From: [John E. Johnson, Jr.](#)
To: [Audra Dye](#)
Subject: [EXTERNAL] Re: 19511 Shrewsbury - HDC application
Date: Monday, July 1, 2024 1:27:43 PM

Once again, here is the design:

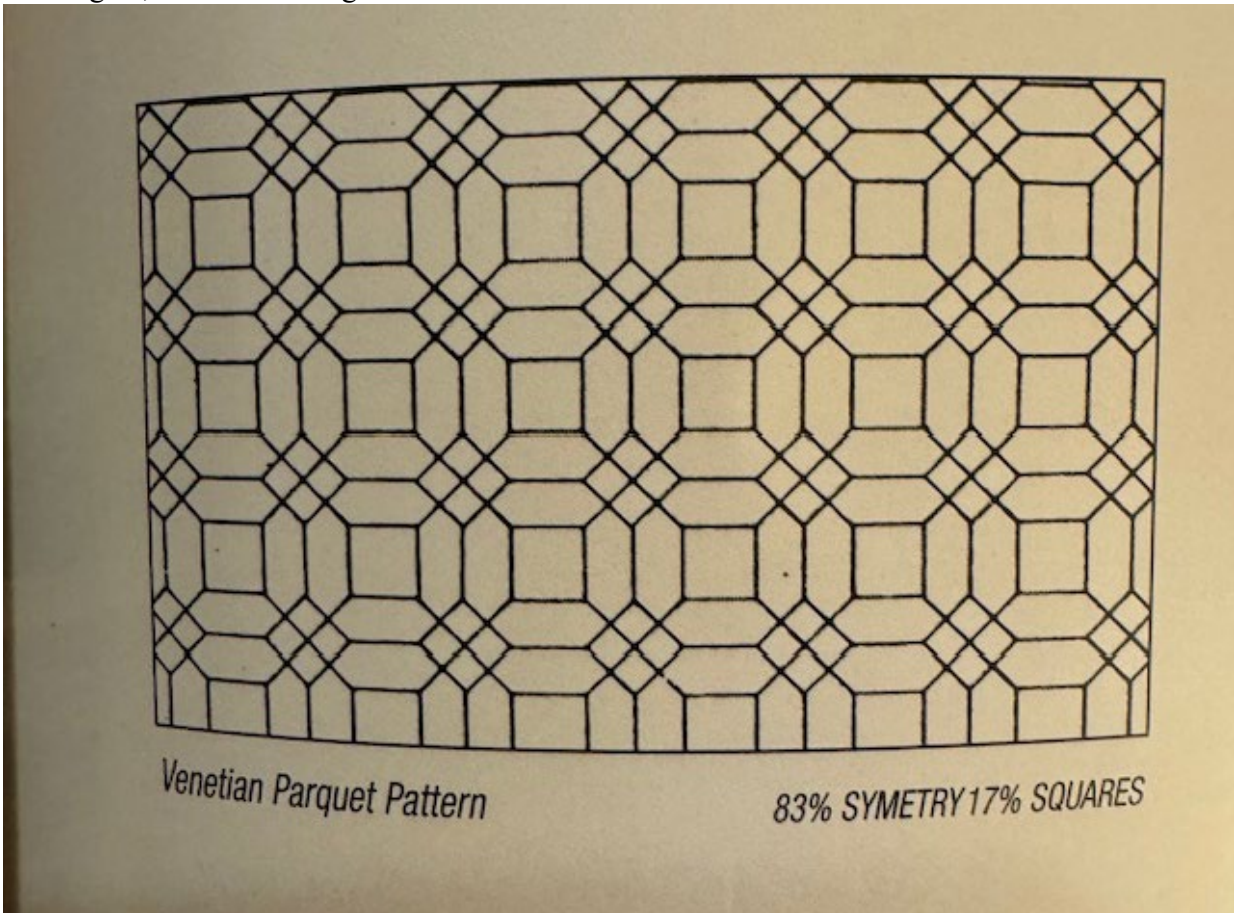
- match the current design as I previously indicated with octagons that are 24" in size (as opposed to the current 12" octagons);
- remove the current stone tiles and brick border (to ensure the proper pitch), leaving the steps and brick wall intact;
- break up the concrete;
- install new ground stone;
- match the rustic colors

Here is another picture of the design, and the dark brown/rust colors that we can use:

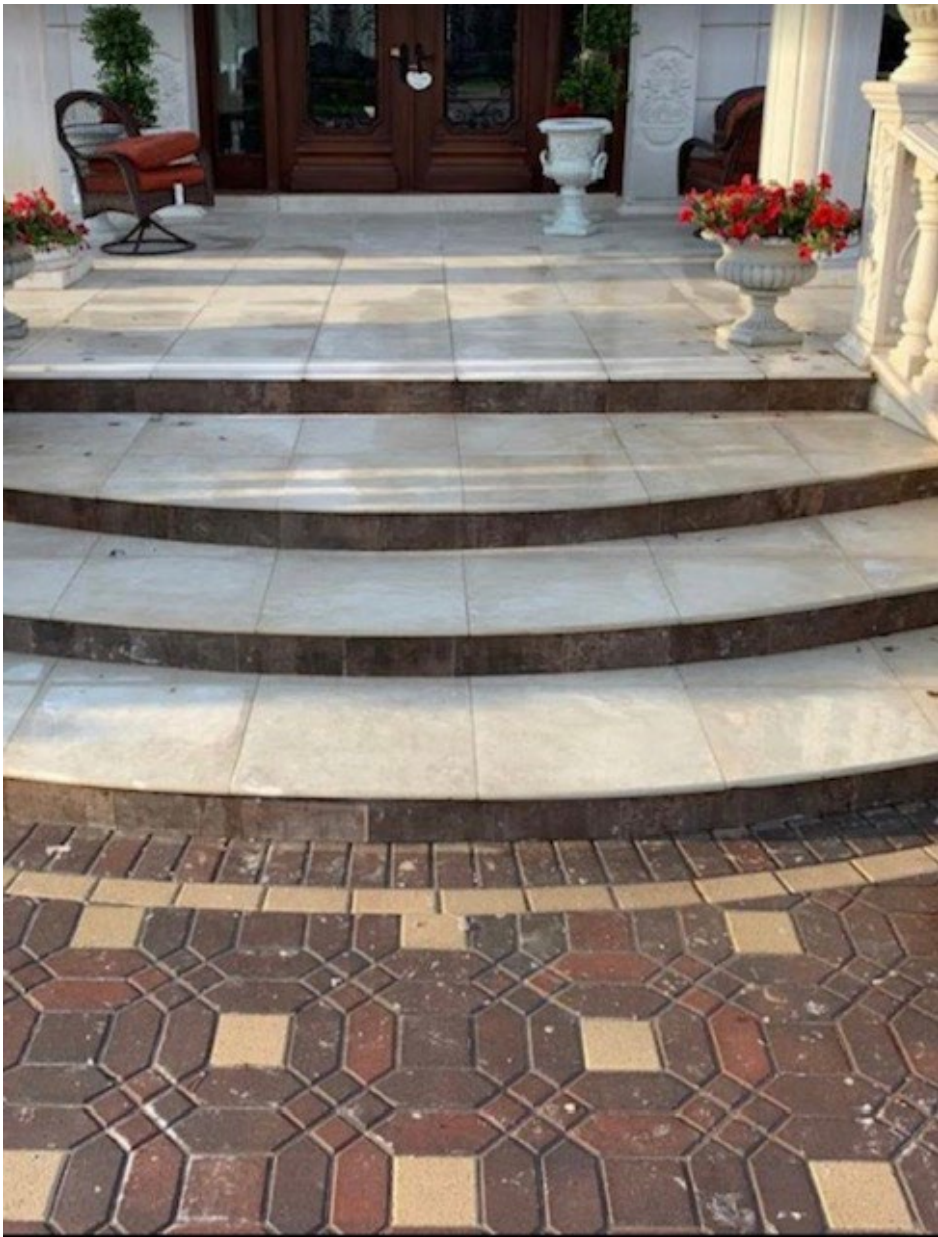
Here is a picture of the type of bricks/tiles he will use, along with pictures of how this can look;
